Re: TTUHSC Preston Smith Library Renovation – Level 01 & 02

**ADDENDUM 02**

TTUHSC Project No: 25-04

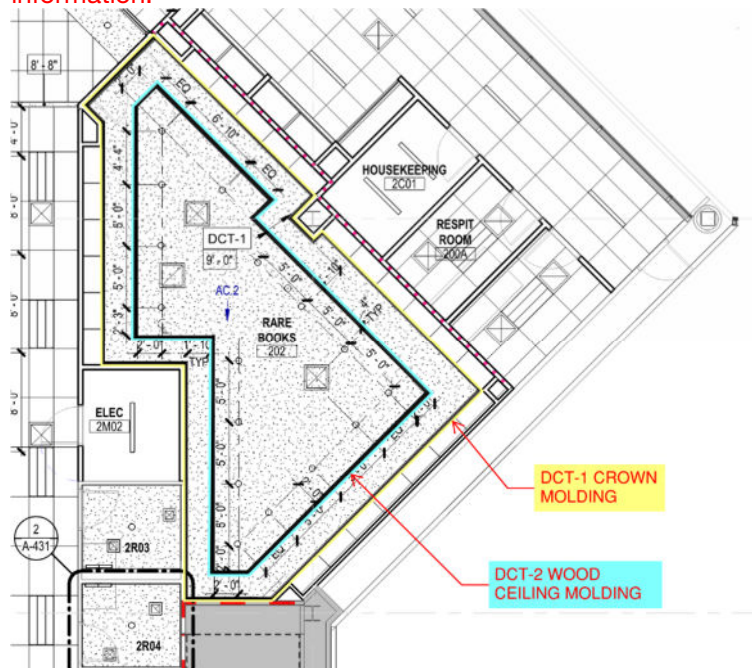
23. Other than details 10 & 11/Sheet A-531, the other details are not referenced on the floor plans and ceiling plans. Please confirm these details are applicable the project and provide references on the RCP clarifying the transition between different materials and height changes.

**RESPONSE:** Yes, typical details are provided as needed for material transitions.

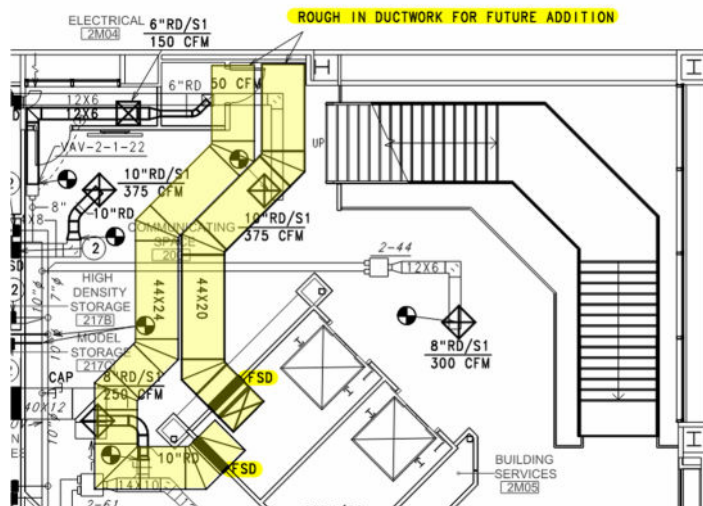
28. Detail 8/A-611 indicates the head detail for the security shutter. Currently no structural steel is shown to support the security shutter or the vertical guides. Please clarify if structural steel will be required.

**RESPONSE:** Yes, assume CFMF below the display openings to support display cases.

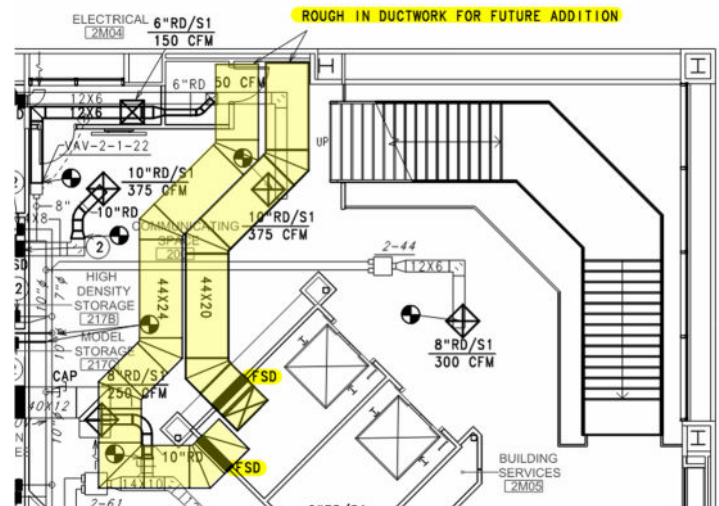
55. The alternates are somewhat confusing can we get a better description of each. The plans call out for 3 alternates the bid sheet has only 2 and during the walk there was discussion of the stairs going to terrazzo being an alternate as well. Please clarify for me. Additionally on alternate 3 electrical how will power and data be routed into the demountable walls.

**Alternate 01** – Price all of the work outlined in the area on Level 01 noted below and denoted with the hatch on A-101 as a separate line item.

**Alternate 02** – Provide a deduct cost for excluding the walls, doors and in wall electrical for the area hatched on Level 02. If accepted, the owner would provide a demountable wall solution. Assume the circuits/power as currently noted would still be routed to the area to power the pre-wired walls. Flooring, ceiling, and finish of exterior walls would remain in the scope of the GC.

**Alternate 03** – Provide a deduct cost for the stair finish being LVT-1 in lieu of terrazzo as identified in the drawings. This alternate is not delineated on the drawings.
